A1 Birtley to Coal House

EXA/D3/003 Applicant's Comments on Responses to EXA's Written Questions

**The A1 Birtley to Coal House
Development Consent Order 20[xx]**

**Applicant's Comments on Responses
to EXA's Written Questions**

Appendix 1.2A - Cross Sections

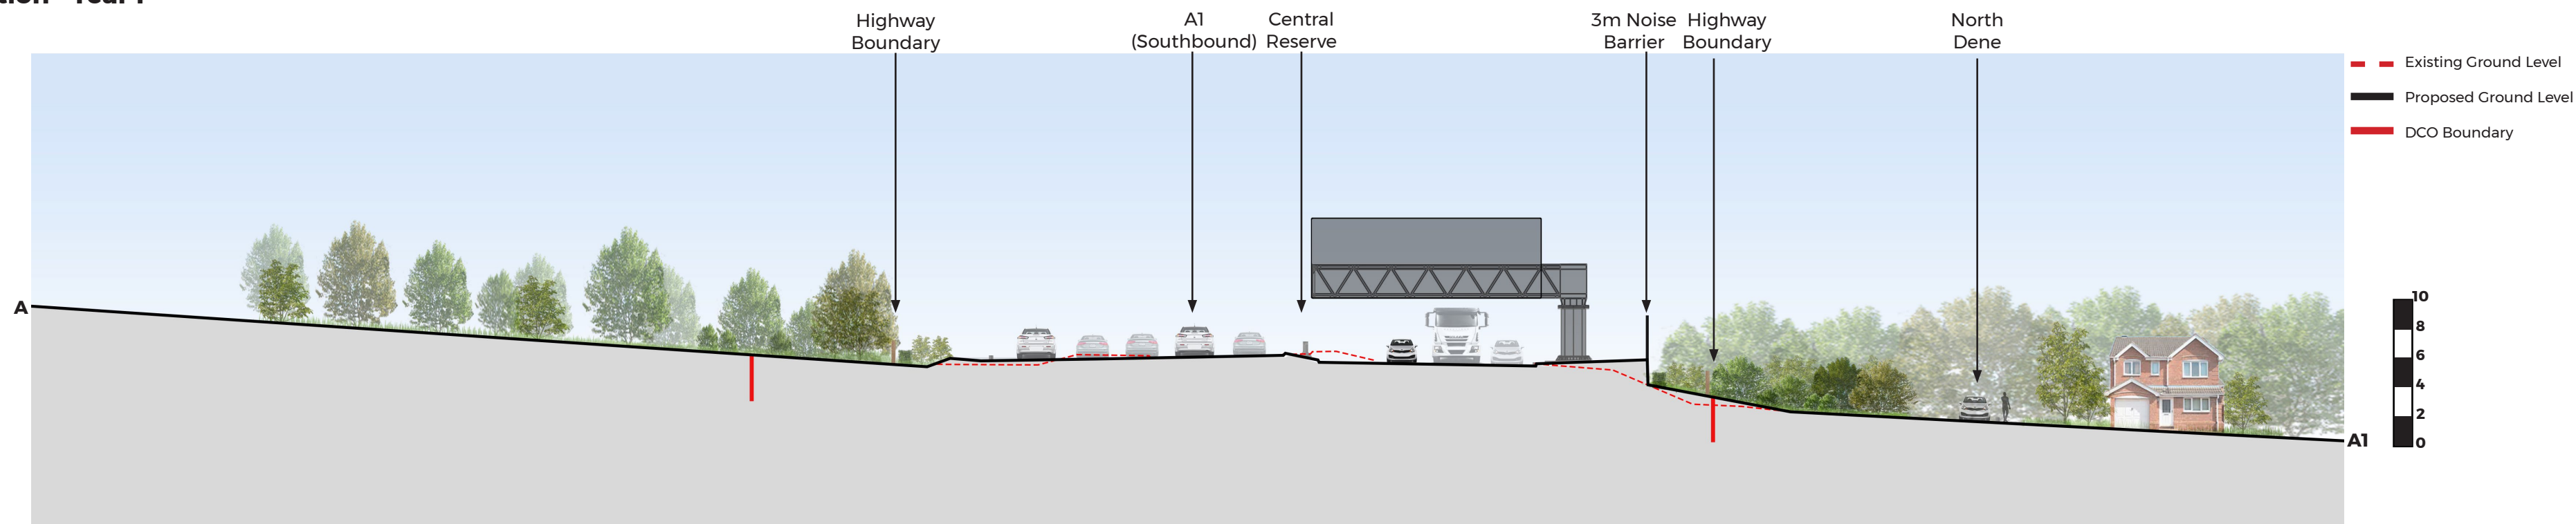
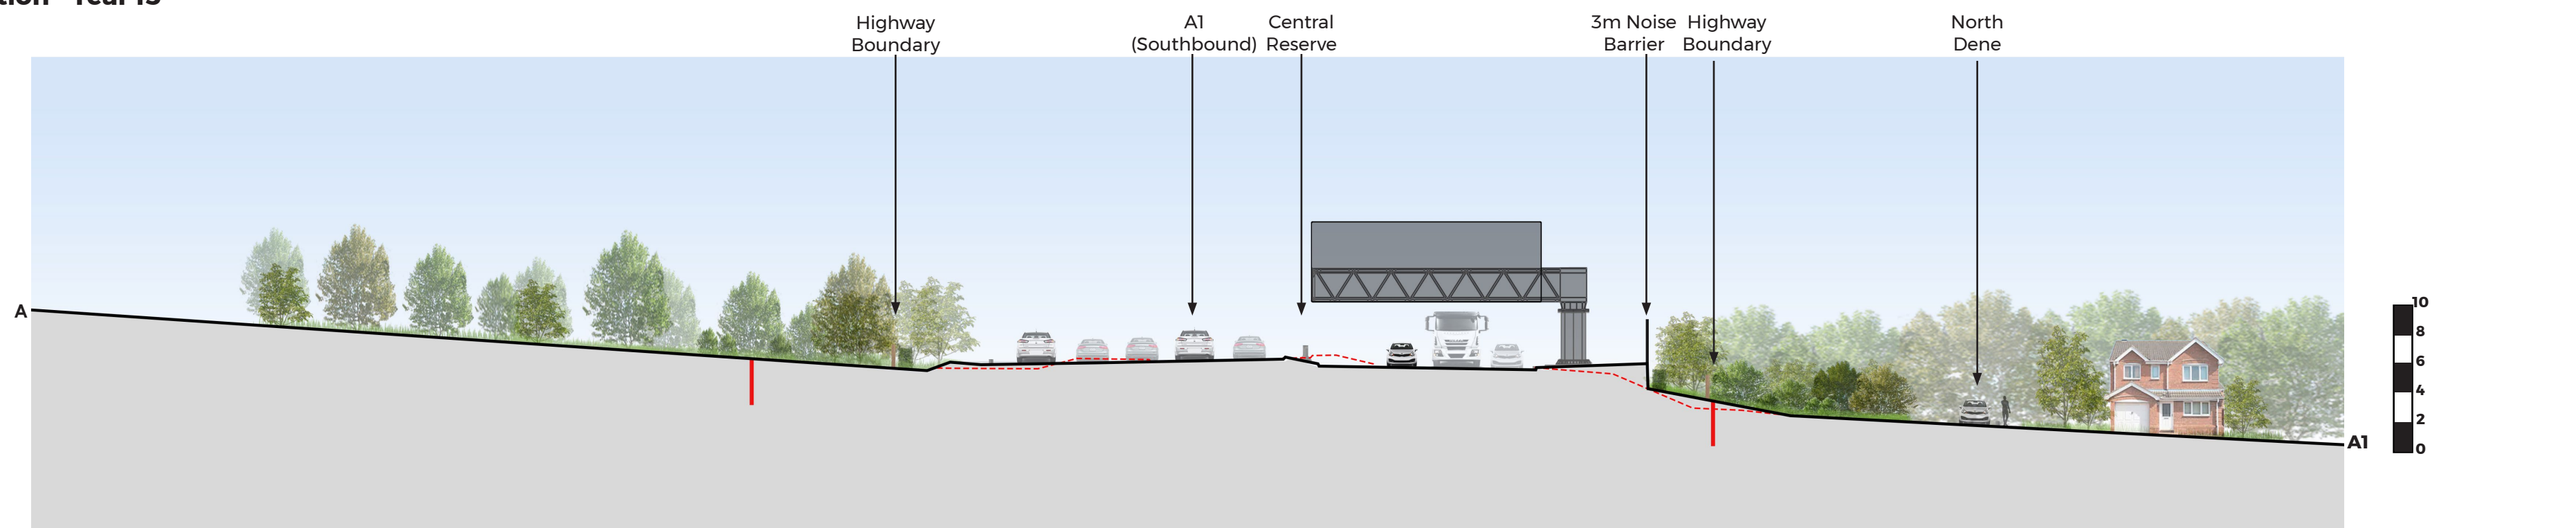
WQ Ref	Question to:	Question:	Response from Gateshead Council	Applicant's comments on the Response
				<p>alternative enhancement or compensatory sites as identified by Gateshead Council within the context of the A1 for woodland and/or habitat improvements that are no longer appropriate in the context of the Angel of the North.</p> <p>The landscape design as outlined in Figure 7.6: Landscape Mitigation Design [APP-061] is complete in that it outlines the approach to mitigation for the Scheme, including the adverse and landscape impacts of the North Dene Overbridge and noise barrier. To address the concerns of the Council, the Applicant has prepared several indicative cross sections to explain the relationship between the A1 corridor, noise barrier, gantries, and replacement planting in combination with existing planting that would be retained and the adjacent dwellings (see Appendix 1.2A).</p>

Figure 1: URBEXT Map

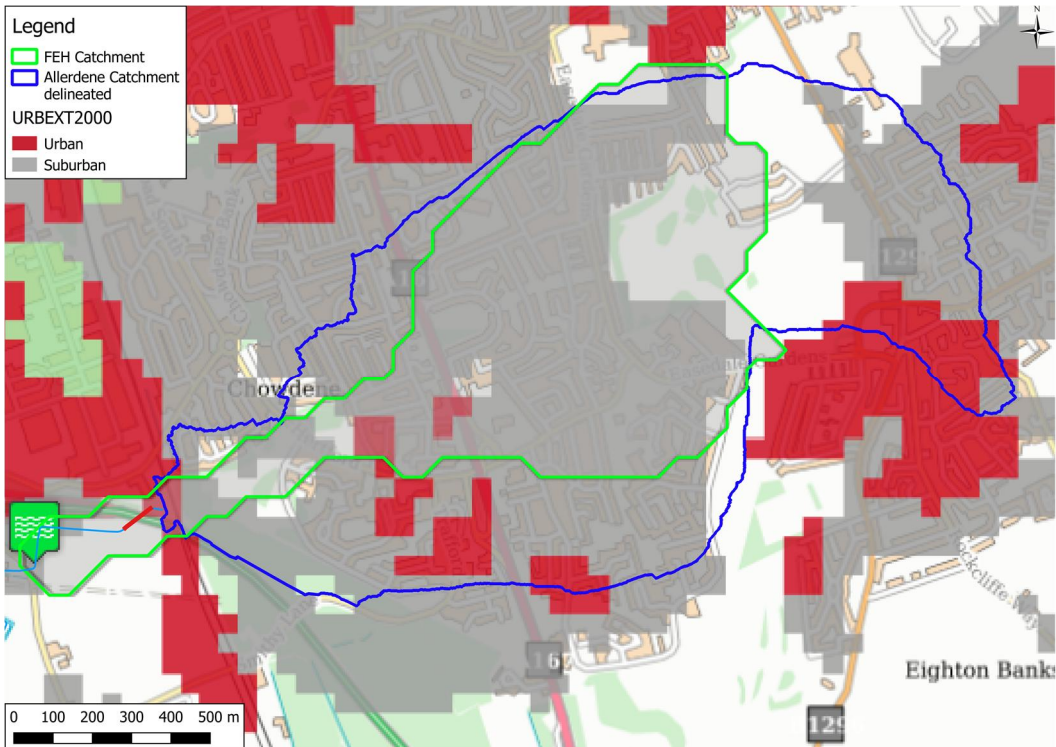
The catchment area has been delineated in GIS and has been compared to the URBEXT coverage, both of which are shown in Figure 1. The catchment descriptors have been updated in line with the identified change in catchment area, these are documented in Table 1

Figure 2 ReFH2 Growth Curves

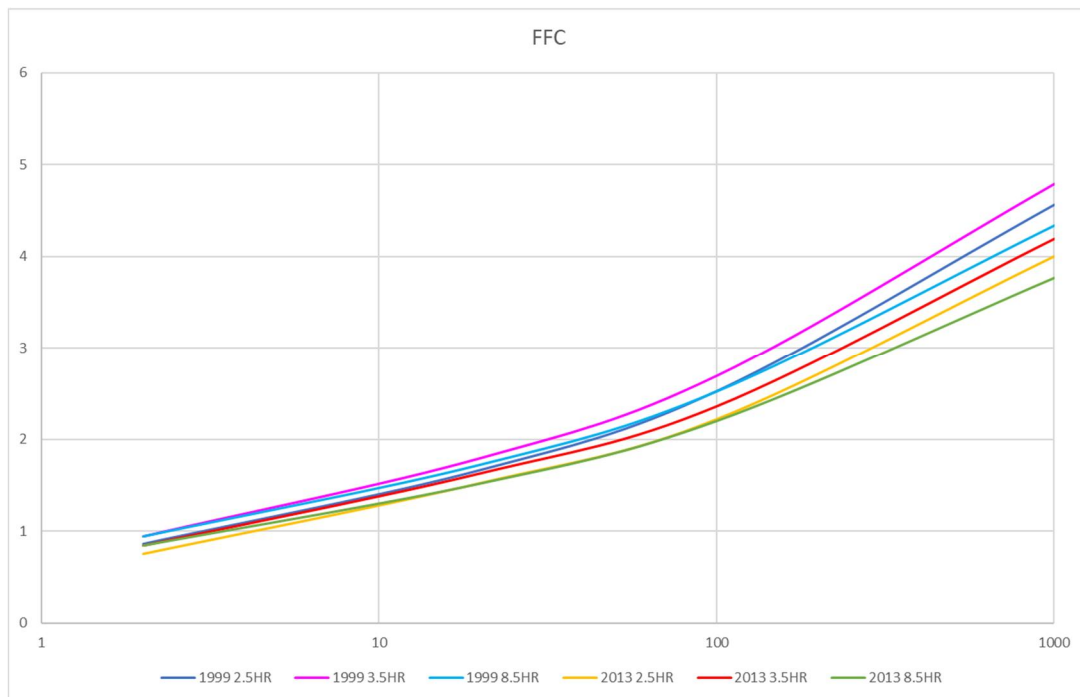
The ReFH2 derived flows have been recalculated (within the ReFH2 software v2.2 and not within ICM) with the refined catchment descriptors as detailed in A-6, the revised flows are detailed in Table 2 and the growth curves in Figure 2, both are below, the key aspects / findings are:

Figure 3: J66 Flood Depths for the 1 in 100 year (1%) event

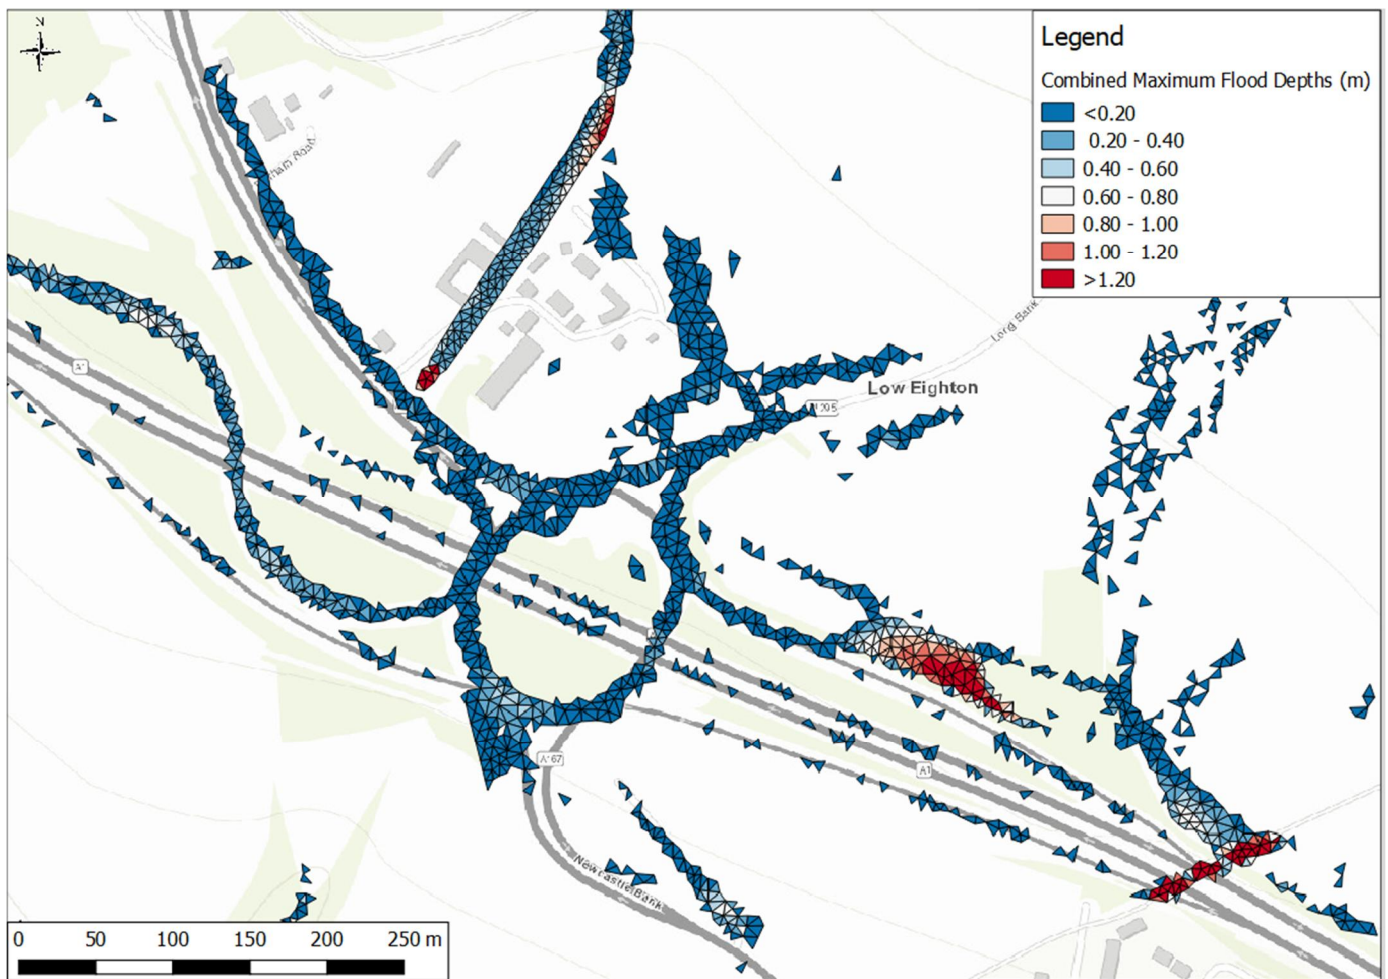
the area of interest. However, as requested all the durations have been run and the results merged to obtain the greatest flood depths. The resultant 1 in 100 year flood map is shown on Figure 3.

Figure 4: Improvements to channel and left bank flows for the Kingsway Viaduct river reach (TEAM_5156.1) because of lowering the bank modular limits to 0.6 (option model)

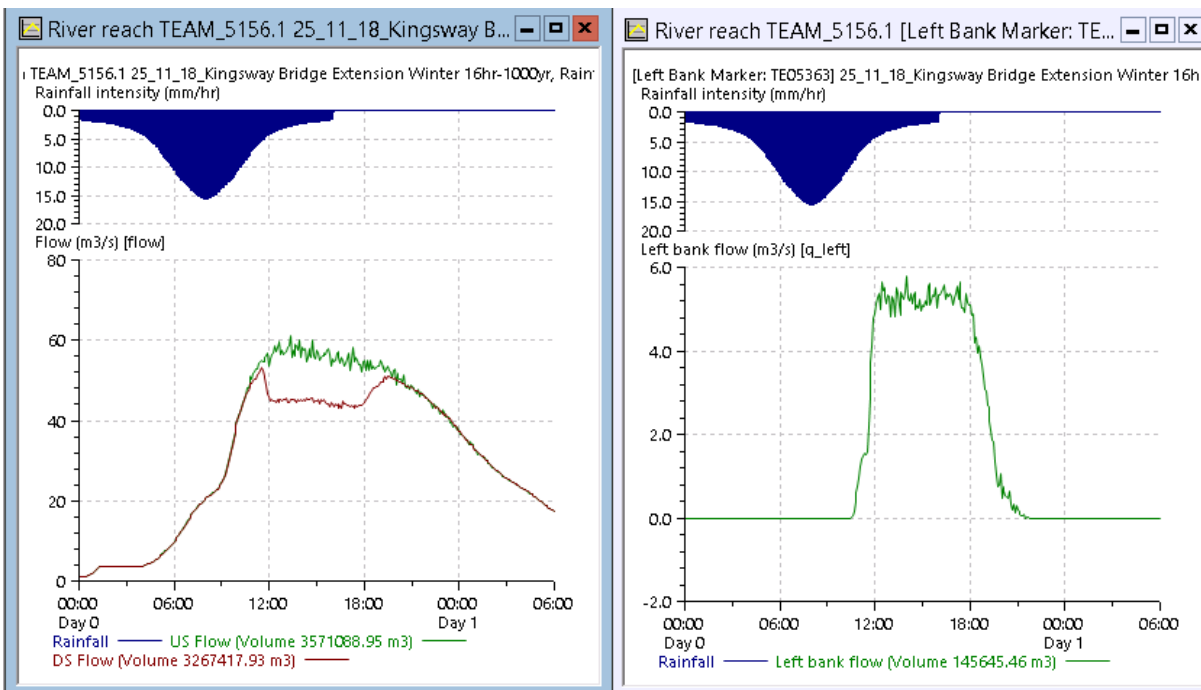
Lowering the bank line modular limit to 0.6 for the TEAM_5156.1 river reach improved left bank flow for the option model, as shown in Figure 4, but caused the original basemodel provided by the EA to fail. The change in modular limit had no impact on in channel flows. The stability problem seems to be a wider issue with the model for example, river reach TE05820.1 directly upstream of the Kingsway Viaduct, shown in Figure 5, shows significant oscillations to in channel and left bank flows. Resolving stability issues with the wider approved and provided Environment Agency model (as developed by JBA) is not required as part of

the evidence base for the Scheme. This is because the A1 is significantly elevated above the River Team and its associated floodplain at this point on a viaduct and the only impacts occur in the future climate change scenarios when the additional bridge piers require a small amount of floodplain compensation (12m³). The model is therefore considered suitable to assess the scale and nature of the proposed impacts.

An attempt was made to improve channel conveyance of river reach TEAM_5156.1 however, this resulted in the model failing to run.

Figure 8: Option 1 channel alignment and flow control locations

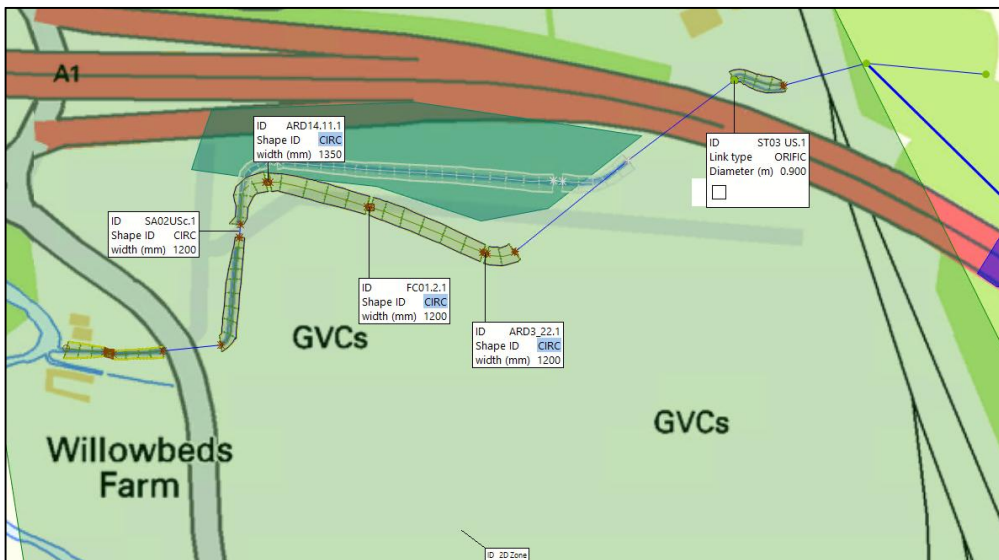
Option 1: requires the extension of the existing Allerdene culvert and realignment of the drainage channel. The proposed drainage channel includes the replacement of four culverts, these are to be replaced with, a 1200mm diameter circular culvert at the downstream end of the channel and a 1350mm and two 1200mm circular culvert at intervals along the channel. In addition, a 900mm diameter circular orifice plate at the upstream end of the existing culvert. These are designed to mimic the existing channel structure, which has three 1350mm culverts, to attenuate peak flows and maximise the available channel storage. The locations and sizes of the flow control structures are shown in Figure 8.

Figure 11: Flow hydrographs at river reach ST02 DS.1 for 1 in 100 year flows with varying roughness

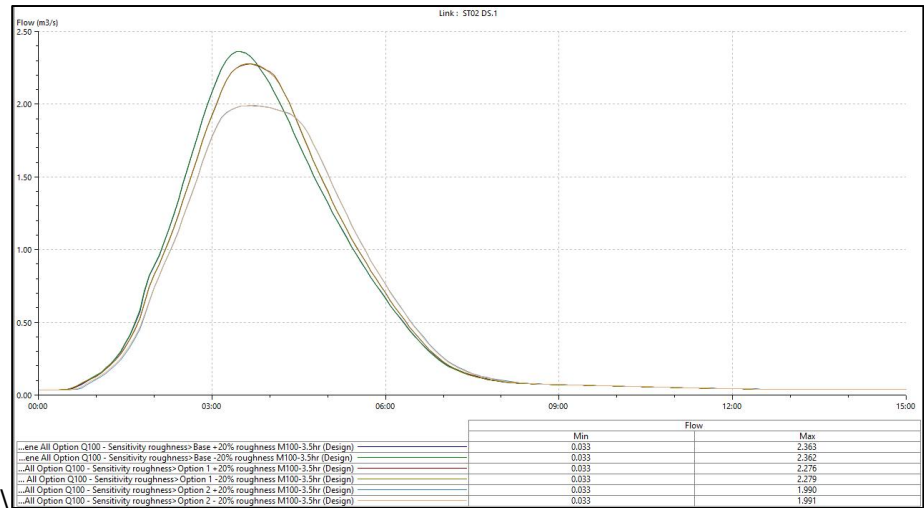
Increasing channel roughness by $\pm 20\%$ has no impact on peak flows (Figure 10). However, for channel depths it does cause the maximum depth to vary by approximately 140-150mm (Figure 11) or approximate ± 70 -80mm compared with the baseline roughness values. This is considered to be within the acceptable model tolerance limits.
